SERVICE BULLETIN

SB98.1

Machines/Models: AB46

PURPOSE: Replace Cage Rotate and Turret Rotate control knobs only.

Figure 1

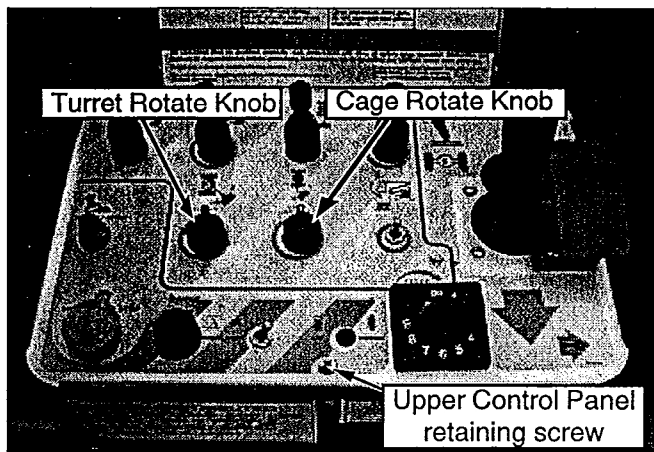
1. Verify key switch is in the off position and upper and lower emergency stop switches are fully depressed.
2. Remove the control panel retaining screws. (Upper controls see figure 1, lower controls see figure 3)

Figure 2

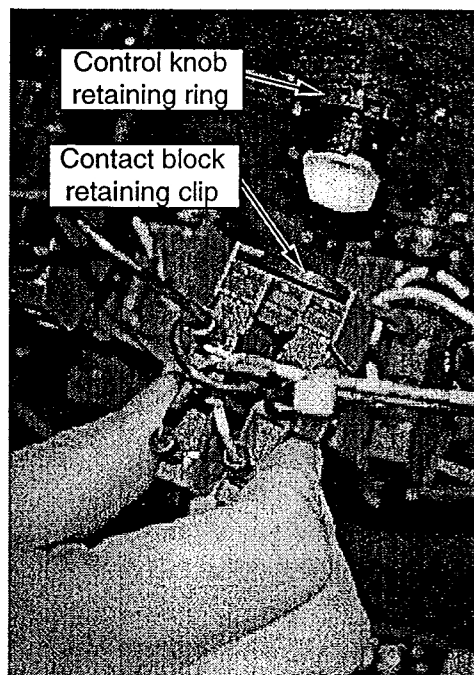
3. Slide the Cage Rotate and Turret Rotate contact block retaining clip counter clockwise, see figure 2. Pull contact block from control knob and position away from knob. **NOTE: Do not remove wires from switch.**

4. Turn control knob retaining ring counter clockwise to remove, see figure 2, remove control knob and discard.
5. Install replacement control knob, Cage Rotate control knob part #068538-002 (mfg. #P9XSMZ3N), and Turret Rotate control knob part #068538-003 (mfg. # P9XSVZ3N) and retaining ring.
